**SHUTTLE ORBITER S-BAND COMMUNICATIONS
EQUIPMENT DESIGN EVALUATION**

FINAL REPORT

Contract No. NAS 9-15514A

**Axiomatix Report No. R7901-3
January 20, 1979**

Figure 43. Dual Coherent/Noncoherent AGC Loop

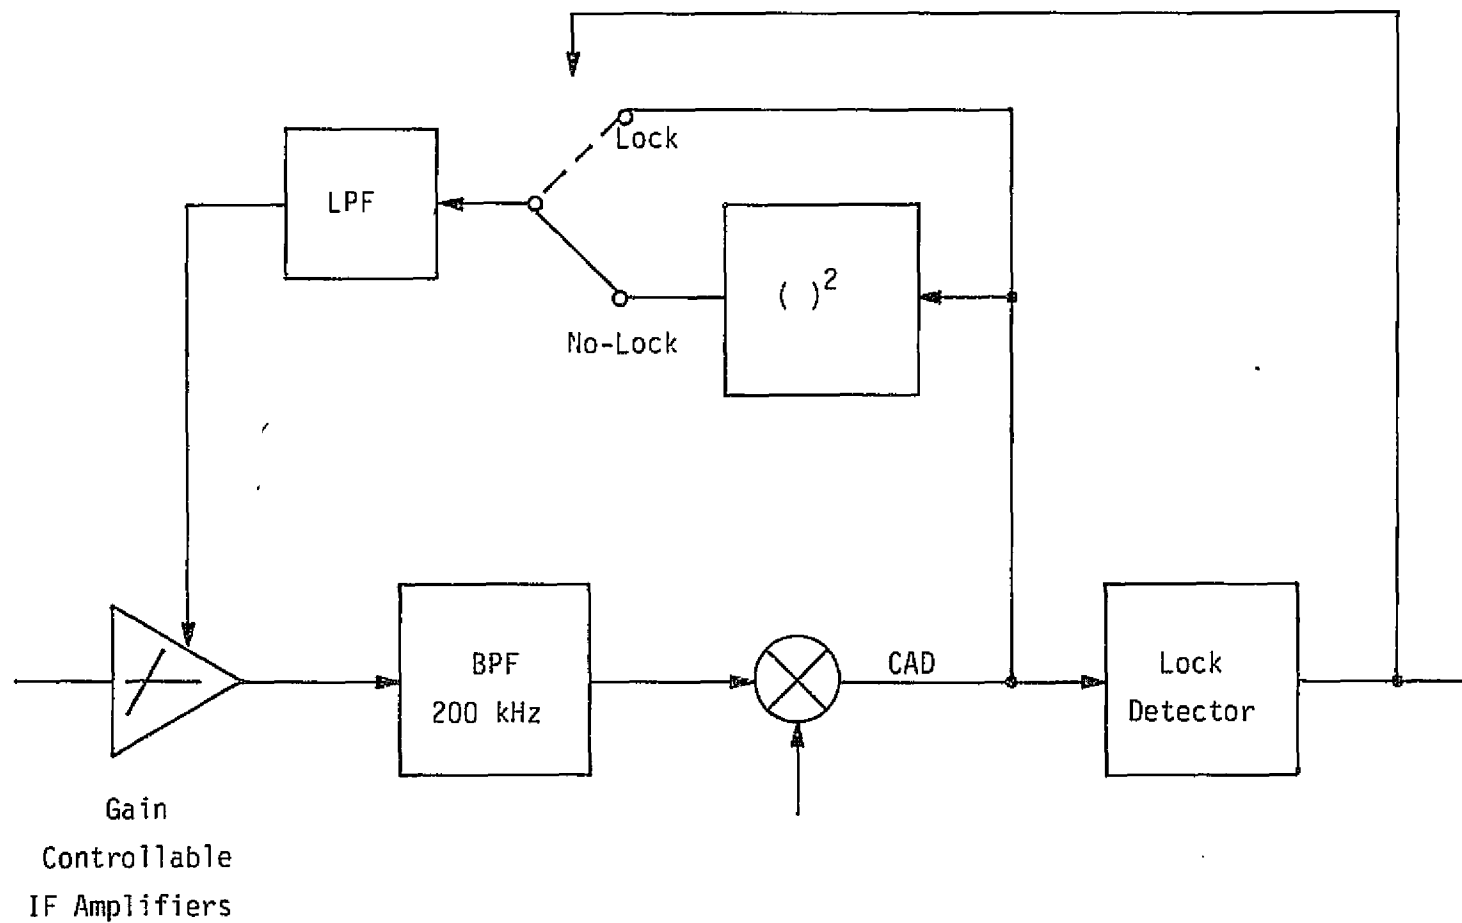
About 8.9 dB total change can be expected, which is significantly superior to the present design approach.
